CLEARWAY, LOT 5

STORM SEWER NOTES AND DETAILS

EL PASO COUNTY FILE NO. PCD # PPR-22-034

# Roadway Plans\_V2 redlines.pdf Markup Summary

212 N. WAHSATCH AVE., STE 305  
COLORADO SPRINGS, CO 80903

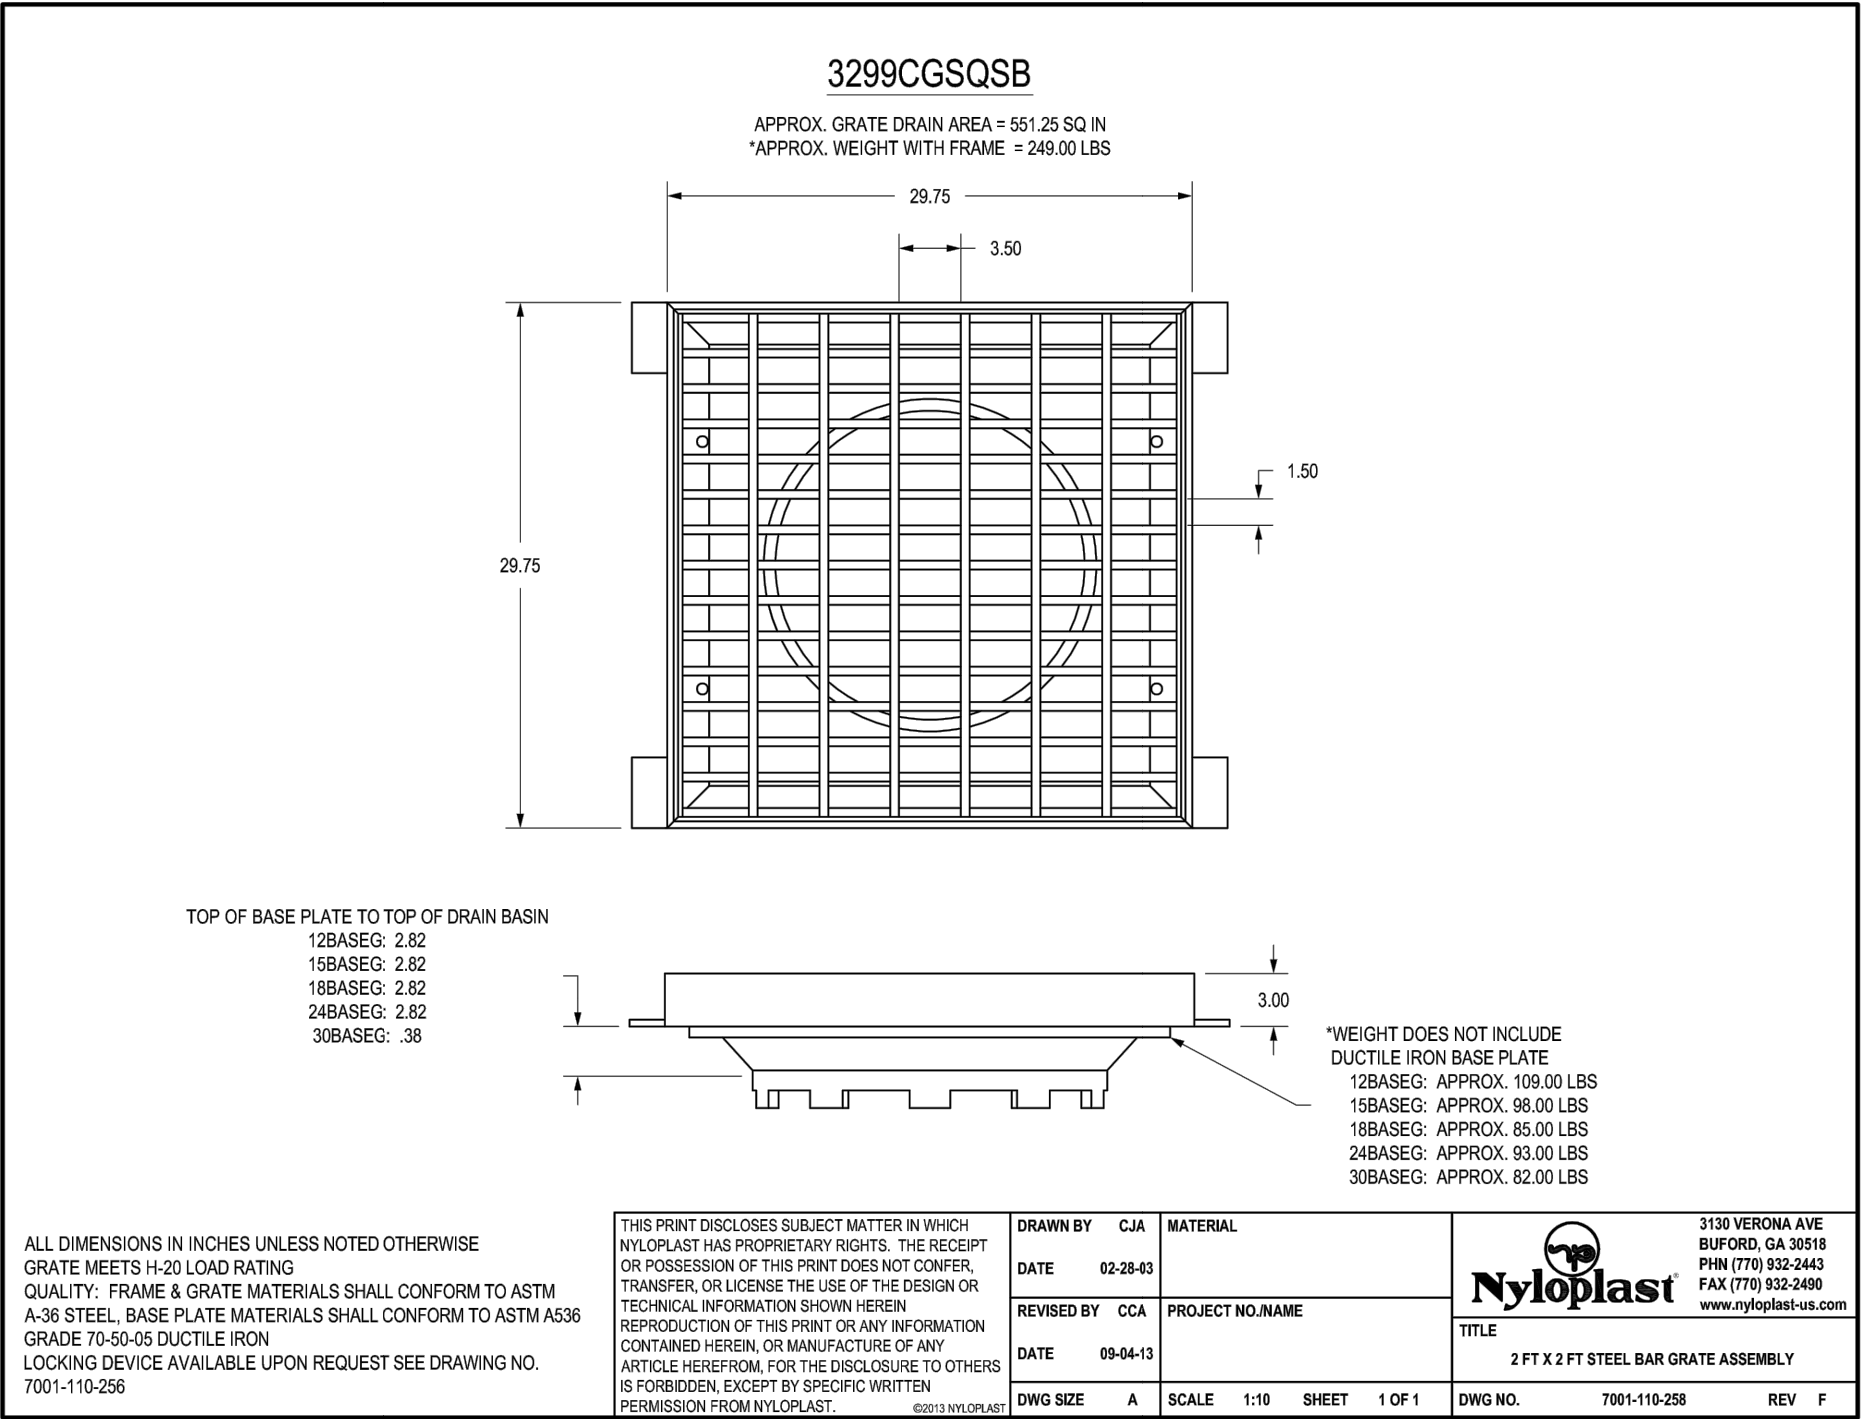
a 2"x 2.5" is identified in the design calculation. Revise accordingly so that they are consistent with each other

CLEARWAY, LOT 5	
OUTLET STURCTURE POND 1 DETAILS	
PROJECT NO. 44-042A	DATE: 09-09-2022
DESIGNED BY: DLM	HORIZONTAL: 1"=50'
DRAWN BY: CLP	VERTICAL: 1"=5'
CHECKED BY: DLM	SHEET 15 OF 16
BMP02

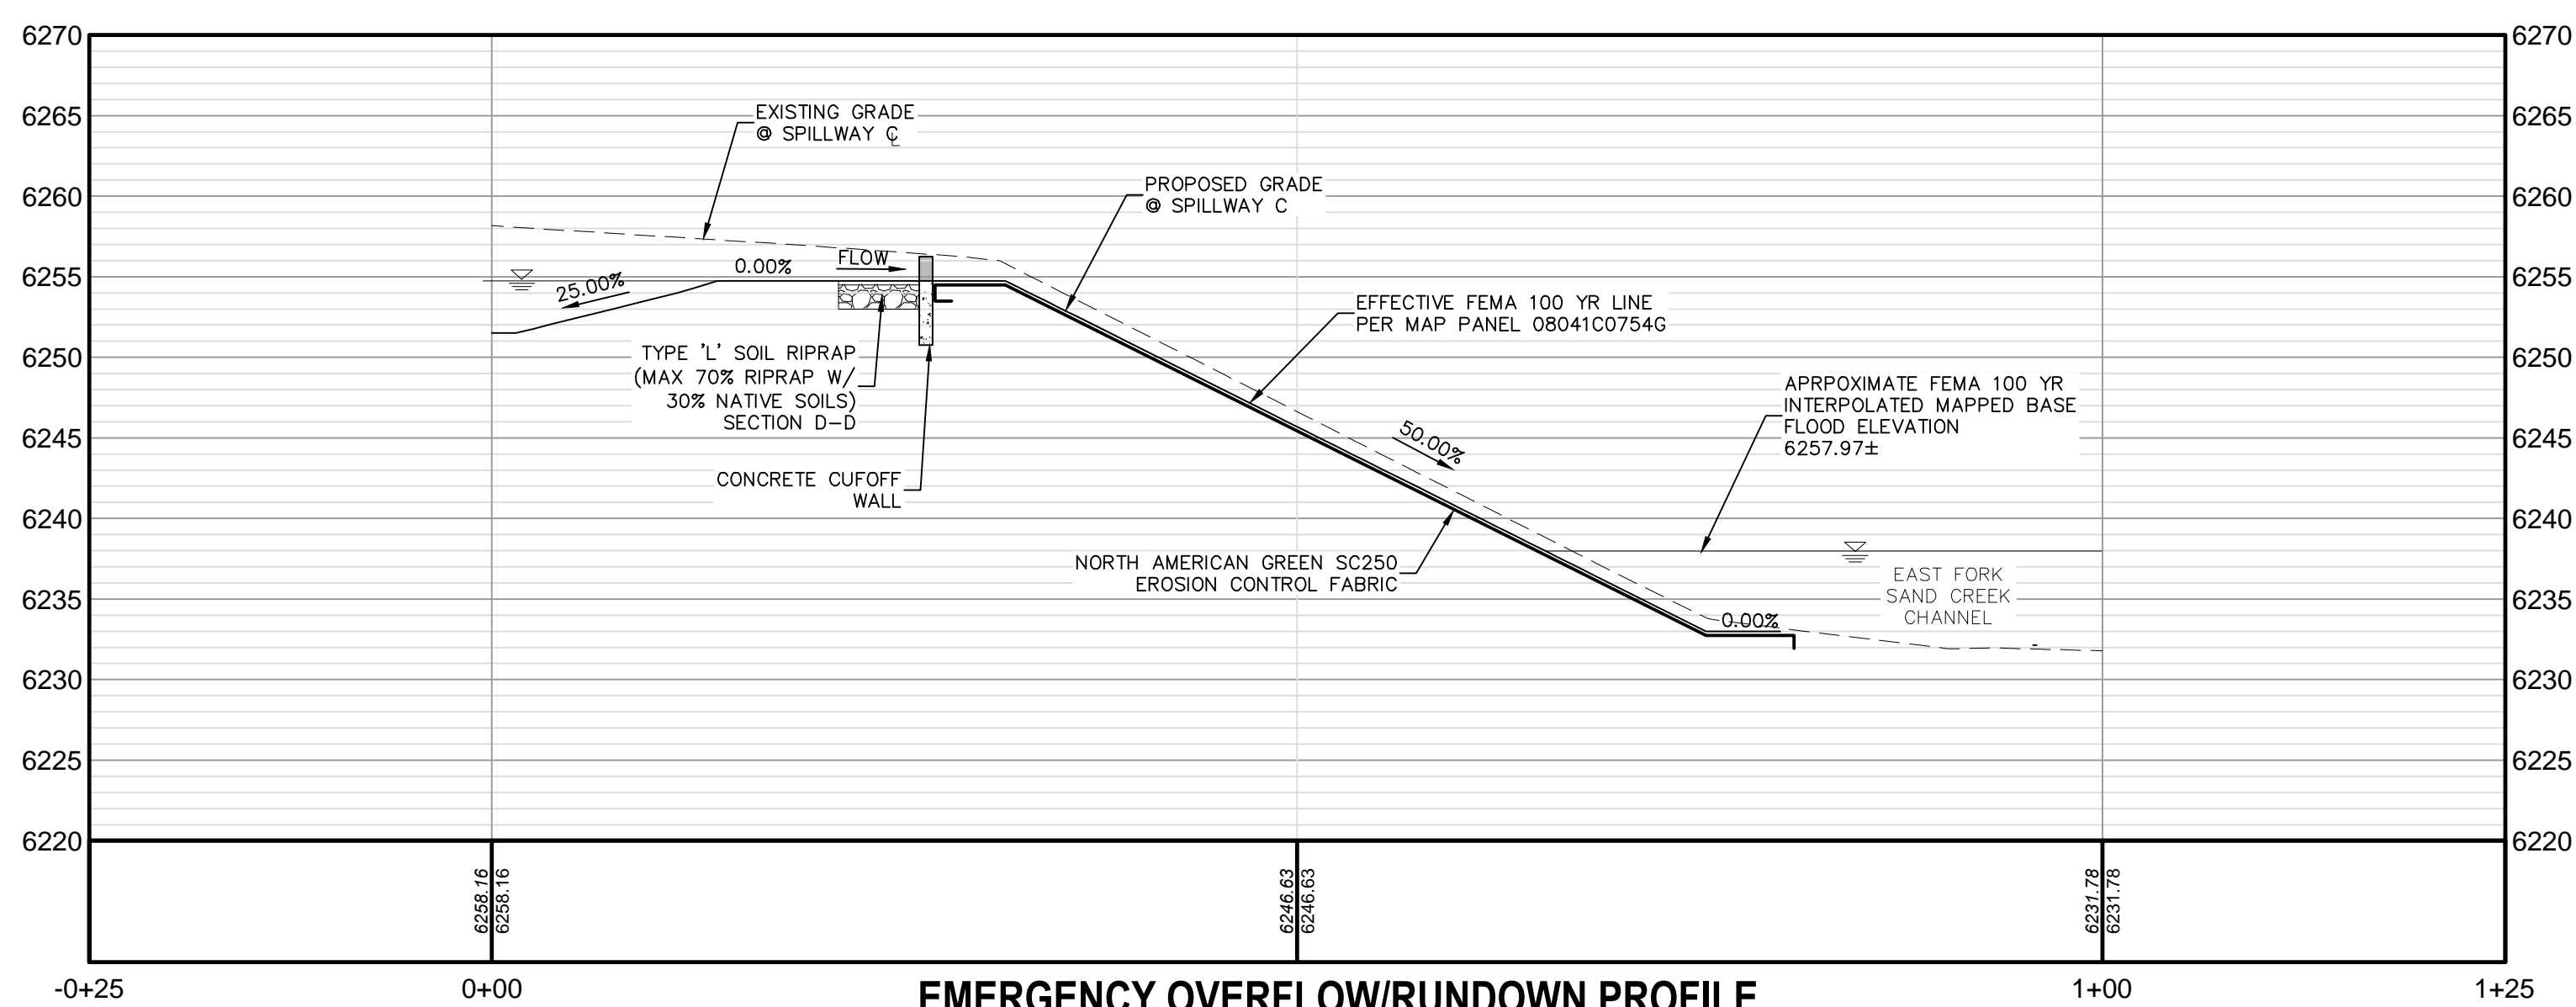
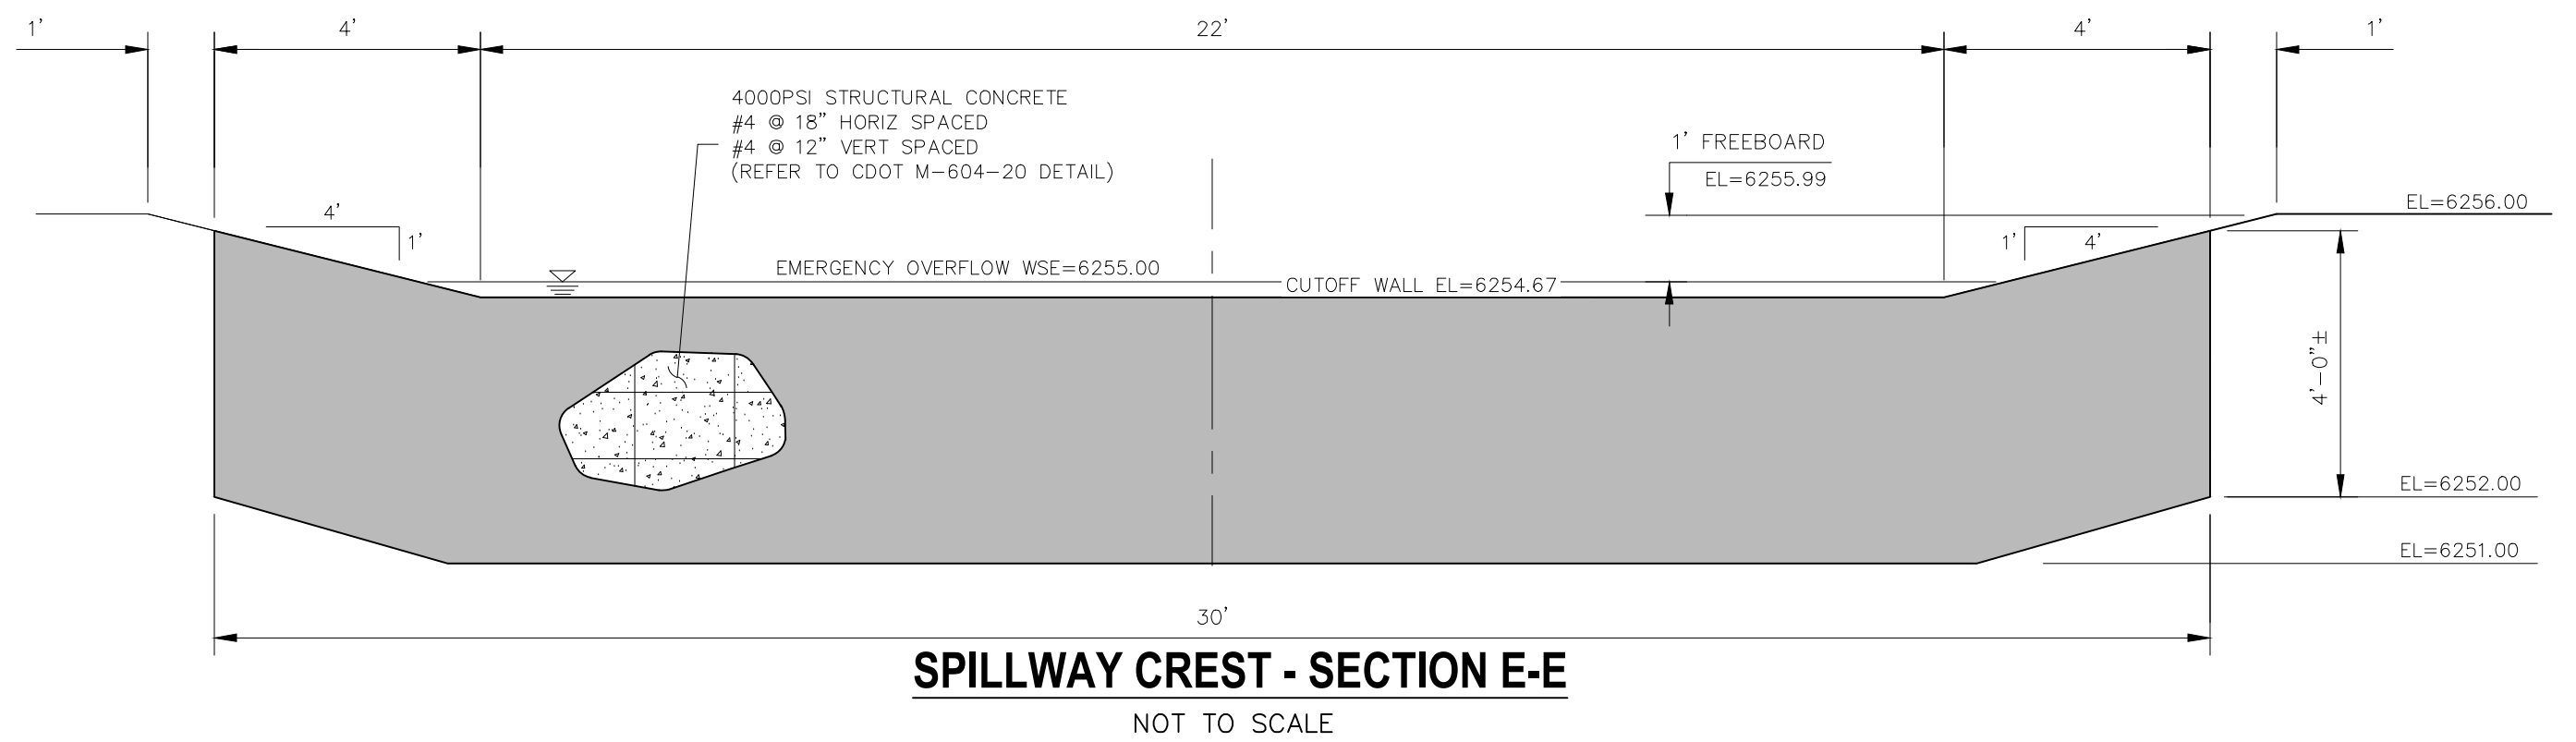
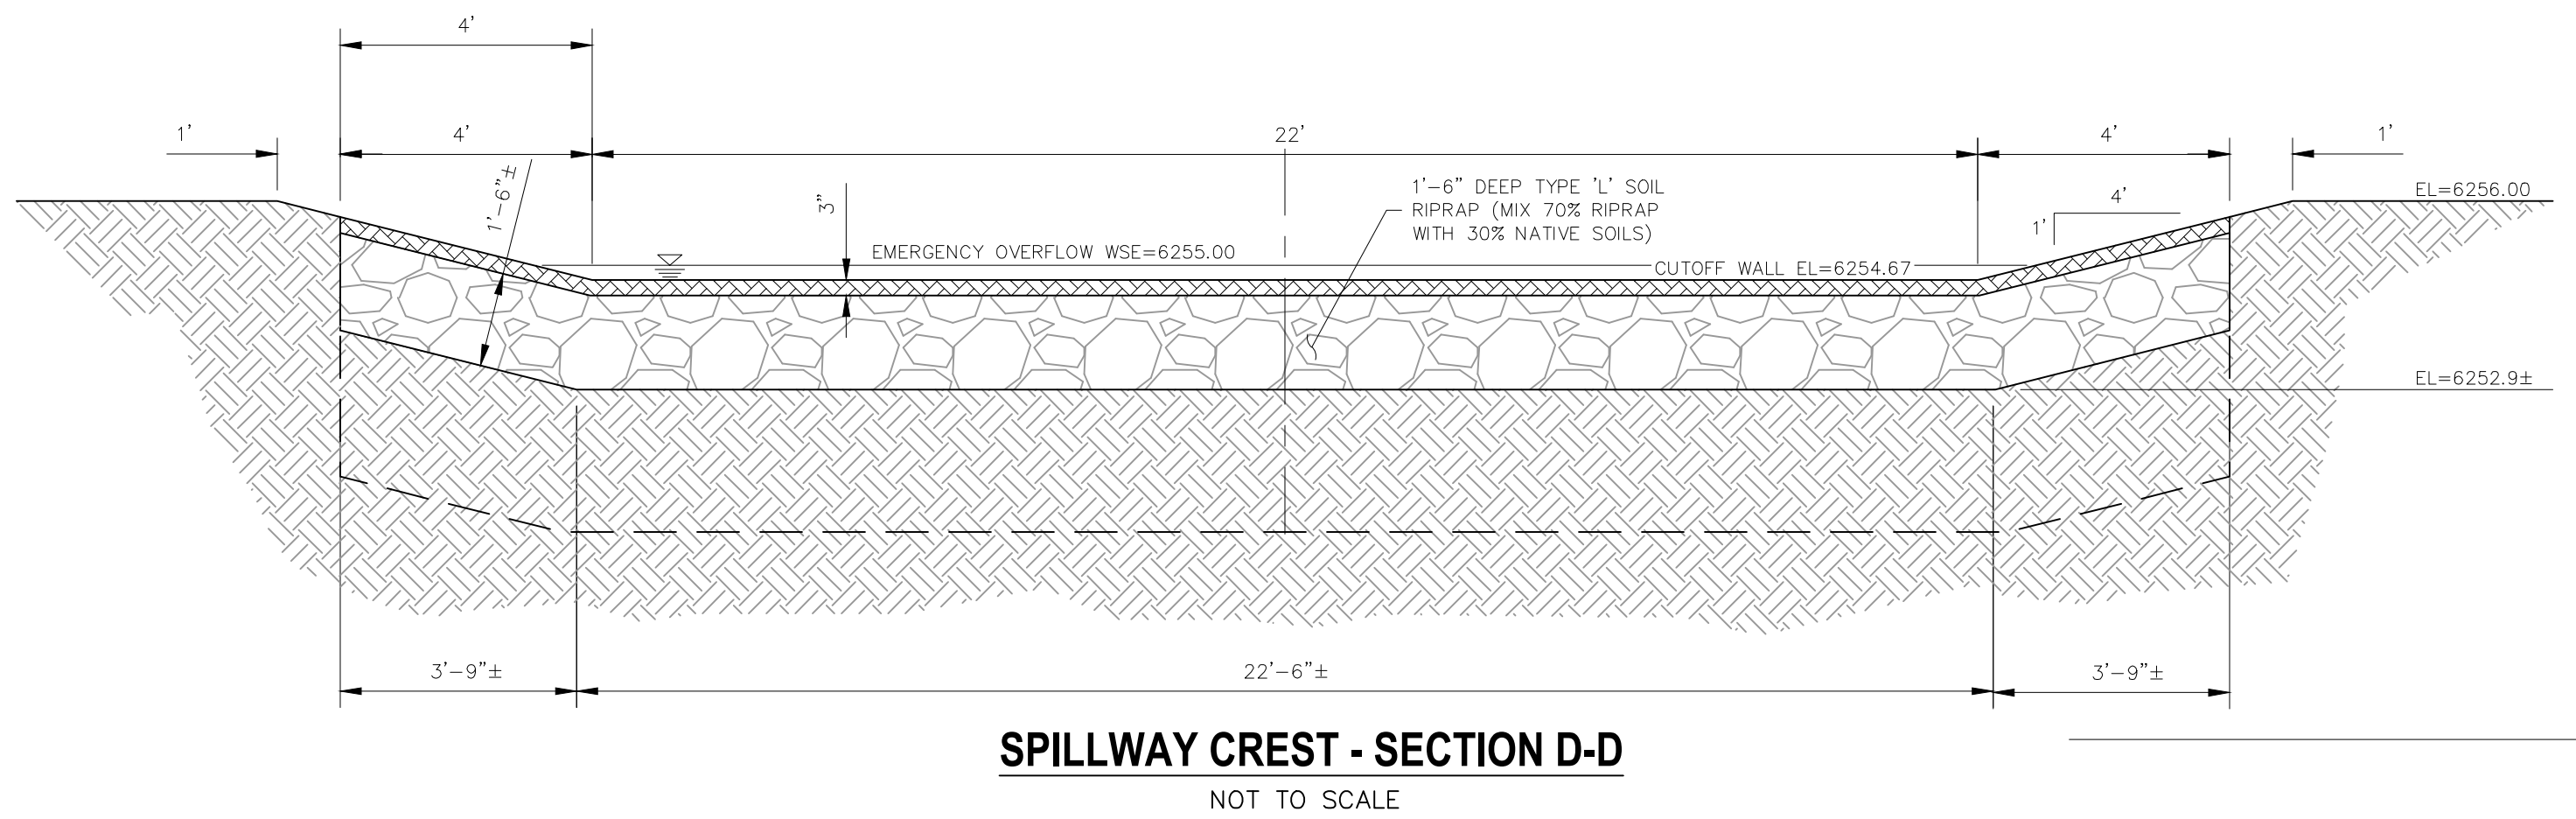
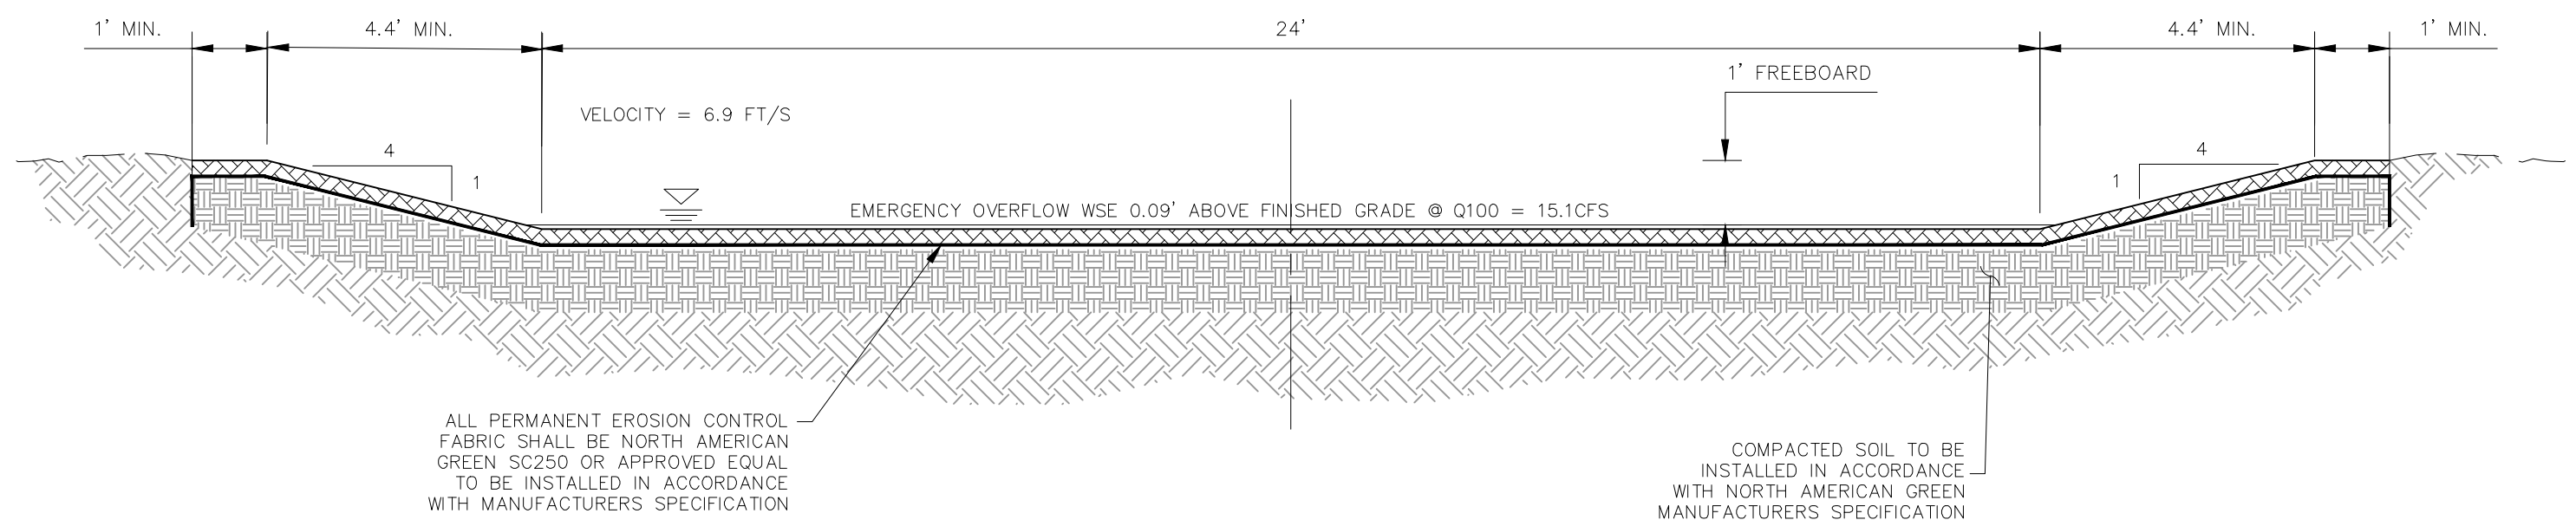
BMP04 not provided. Revise accordingly
